February 1, 2017

**Grand Bay Coastal Resources Center Decking
Biloxi, MS**

00.910 ADDENDUM NO 1.

A1.0R

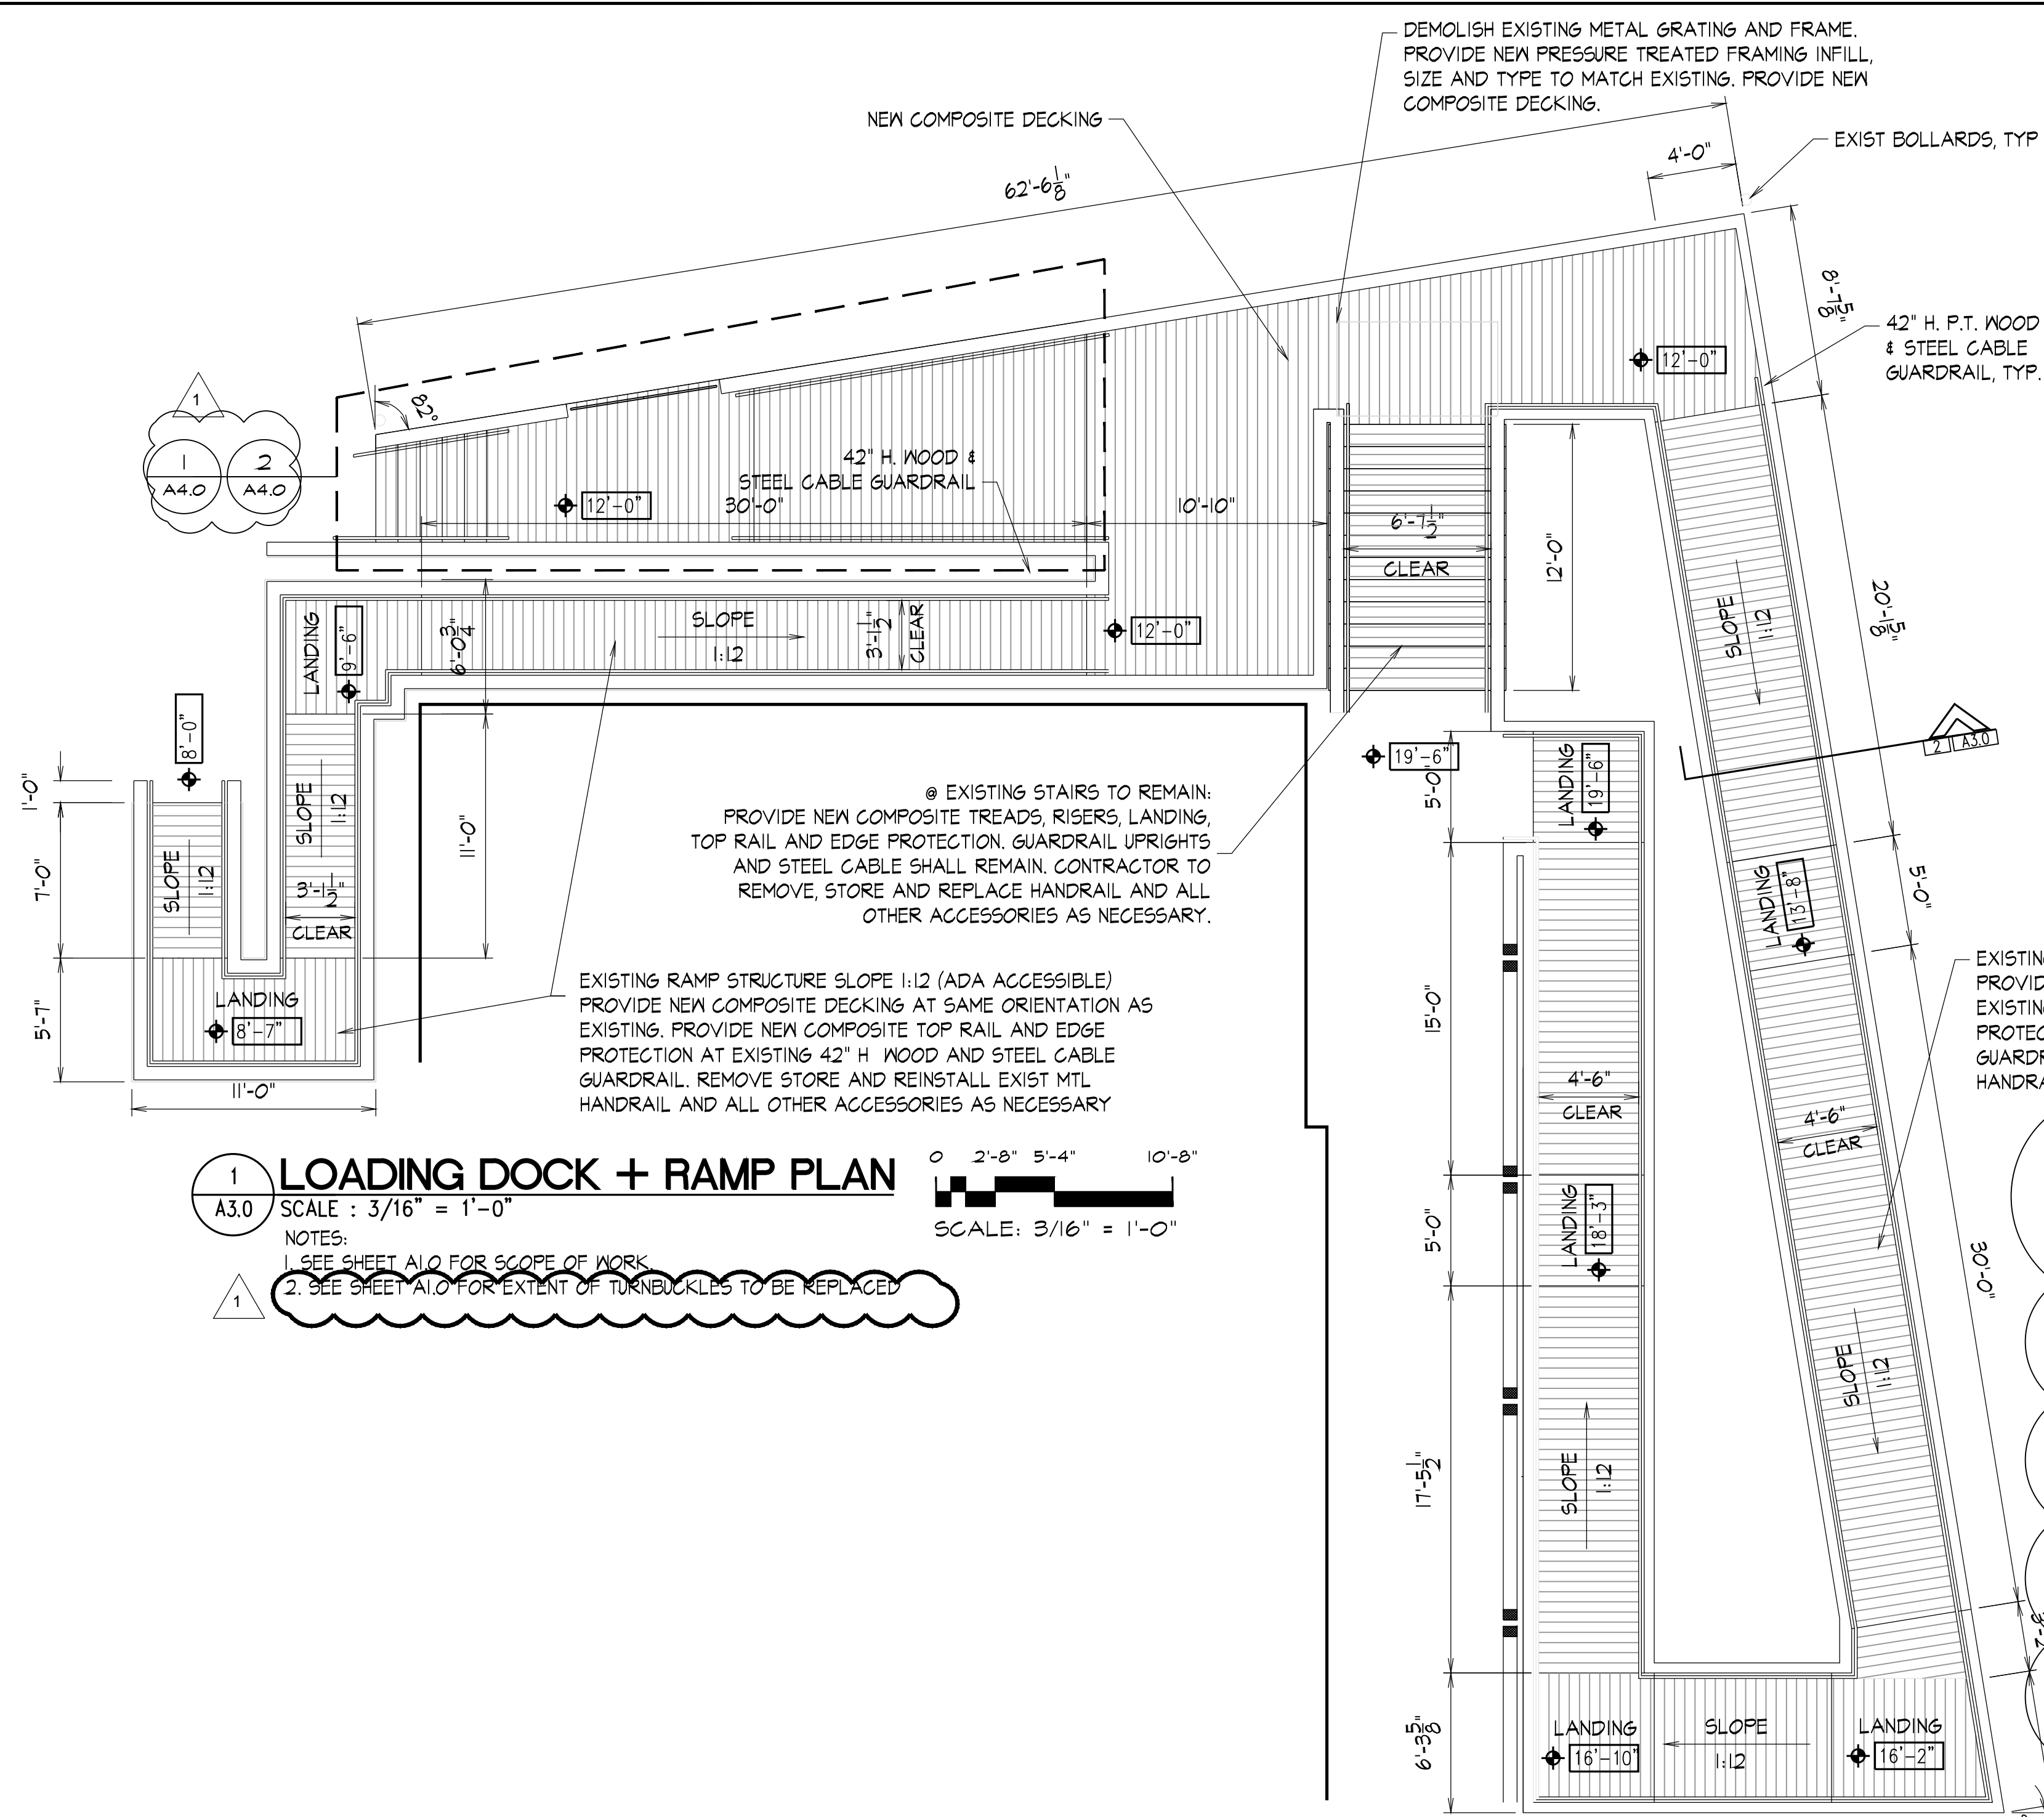
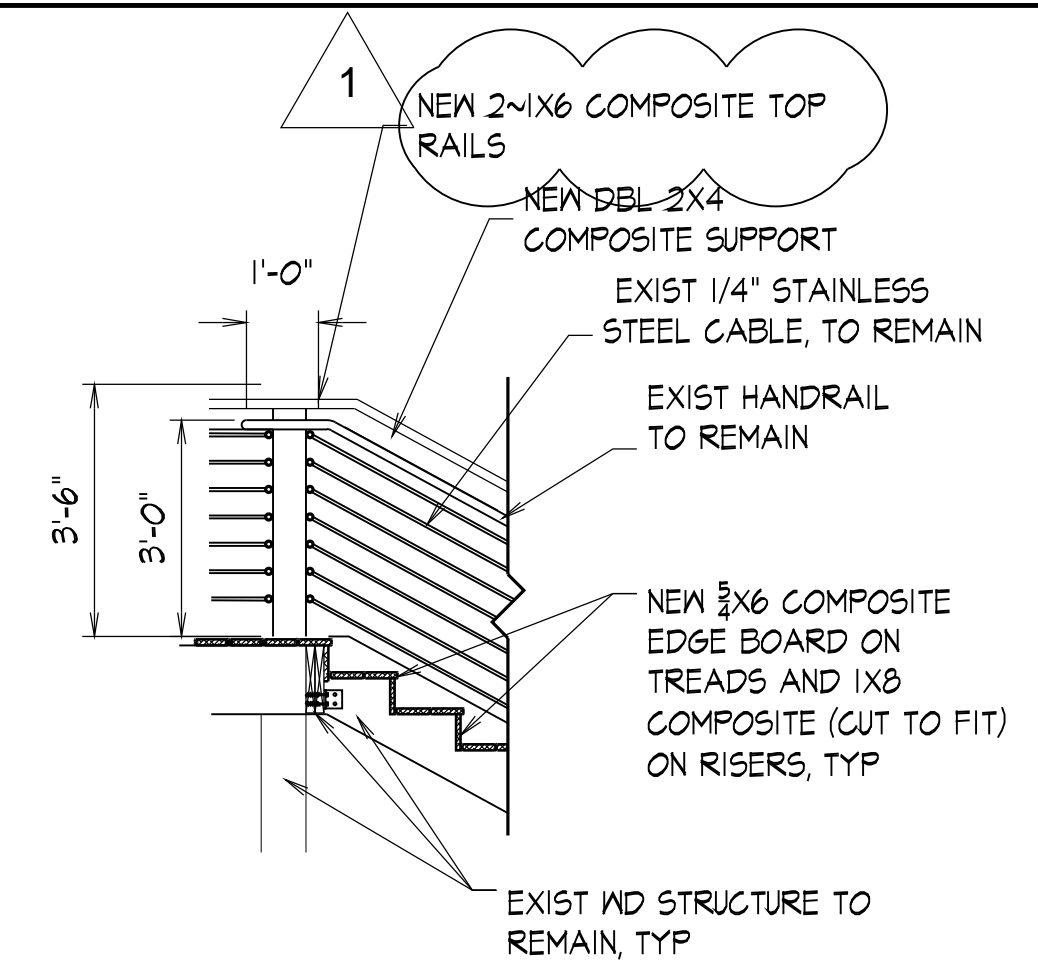
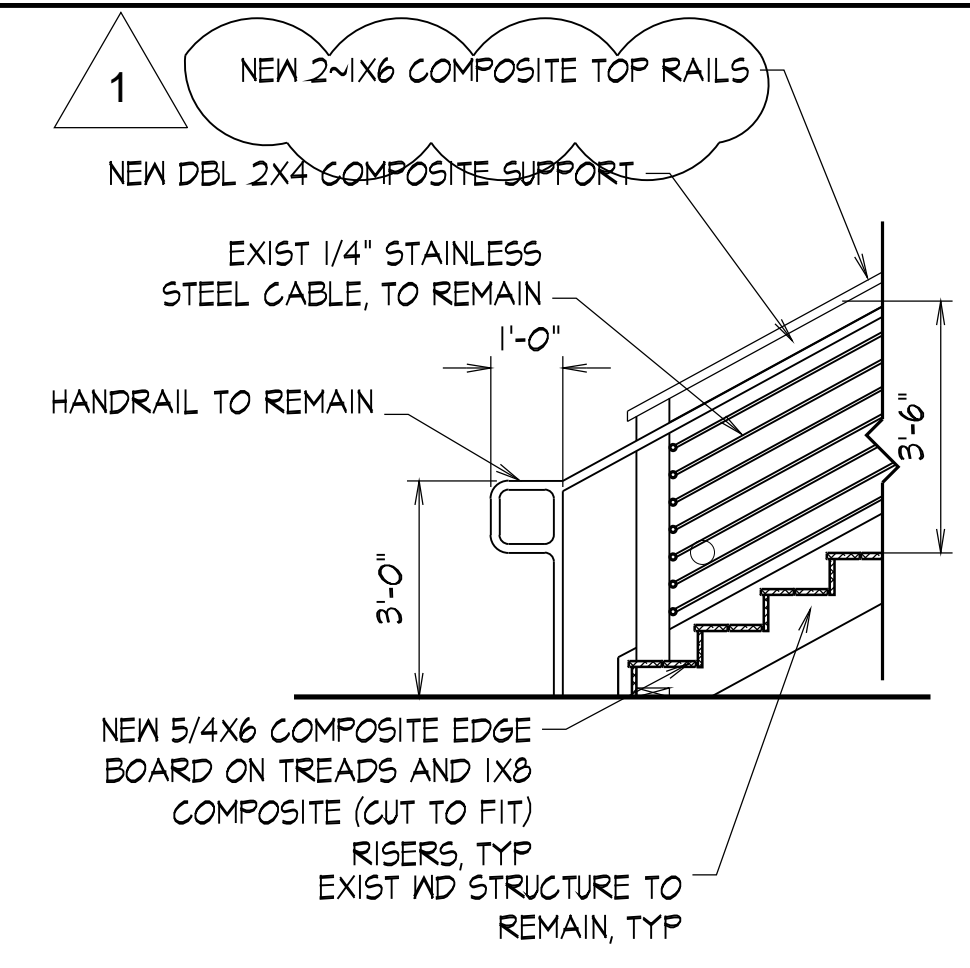
1. Delete sheet A1.0 in its entirety and replace with sheet A1.0R. Update the sheet index to match.
2. Delete sheet A3.0 in its entirety and replace with sheet A3.0R. Update the sheet index to match.
